### City of Mississauga Department Comments

Date Finalized: 2022-01-05 File(s): A574.21

Property Address: 3389 Stoney Crescent

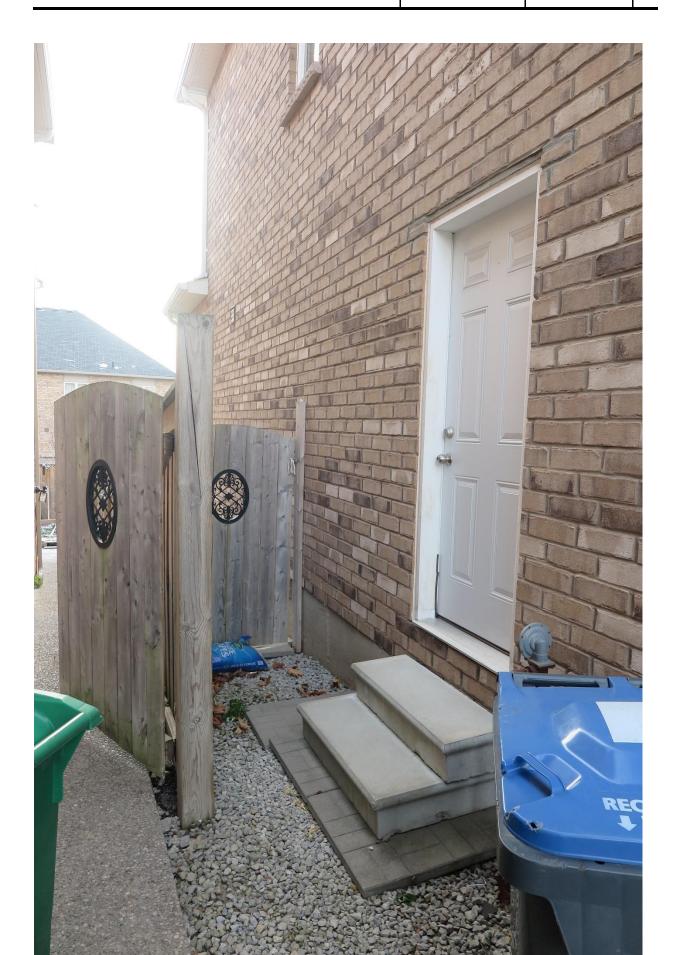
From the enclosed are photos we note that the existing side door is at a much higher elevation than the existing grade. The Notice of Public Hearing indicates a below grade entrance having a setback of 0.30m, whereas DWG No: A-1 submitted indicates a wood deck/stairs with 3 risers leading to the basement.

Regardless of the information submitted, the proposed entrance will be located at the high point and the drainage pattern should not be impacted, however access to the rear yard will be restricted.
